AMENDMENTS TO THE DRAWINGS

Application Serial No.: 09/450,802
Title: Method And System For Source Synchronous Clocking
REPLACEMENT SHEET

FIGURE 1

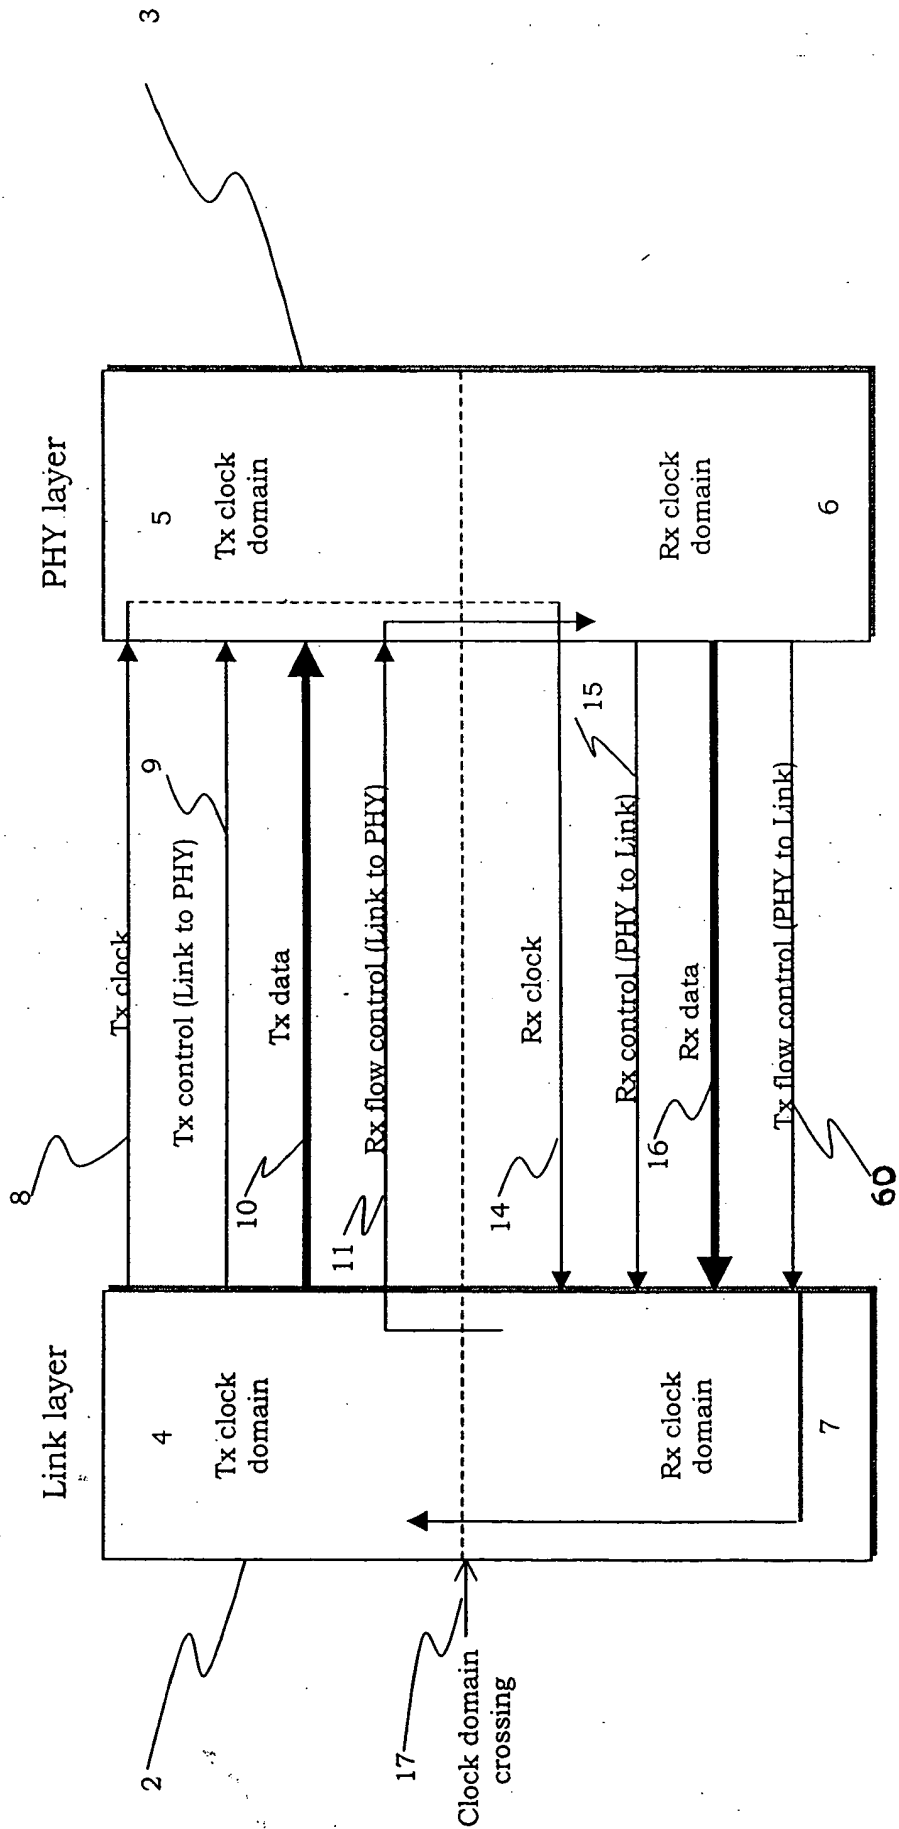
The attached sheets of drawings include changes to Figs. 1 and 2. These sheets replace the original sheets including Figs. 1 and 2. Figs. 1 and 2 have been amended to conform more clearly with the corresponding detailed description. In particular, Fig. 1 has been amended to remove reference numeral 13 (which does not appear in the corresponding detailed description) and to replace reference numeral 17, used to describe the TX flow control signal, with reference numeral 60. The detailed description has been amended to reflect the use of reference numeral 60. Fig. 2 has been amended to remove reference numeral 12, which does not appear in the corresponding detailed description.
